WORK DESCRIPTION FOR FIELD MEASURE

Code: 21P3290203 **Version: 2.0**

Correct torque of screw connection between hydraulic lines and all suspension struts

Model 223

Figure 1

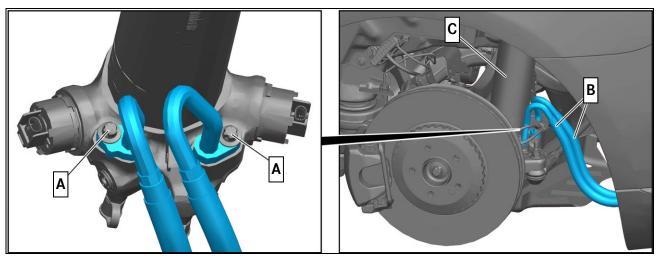
- 1. Lift vehicle with vehicle lift.
 - i For basic data, see AR00.60-P-1006A.
- 2. Correct torque of screw connection (A) between both hydraulic lines (B) and all suspension struts (C) on the **front and rear axles** (Figure 1).
 - i Screw connection torque between hydraulic line and suspension strut 27.
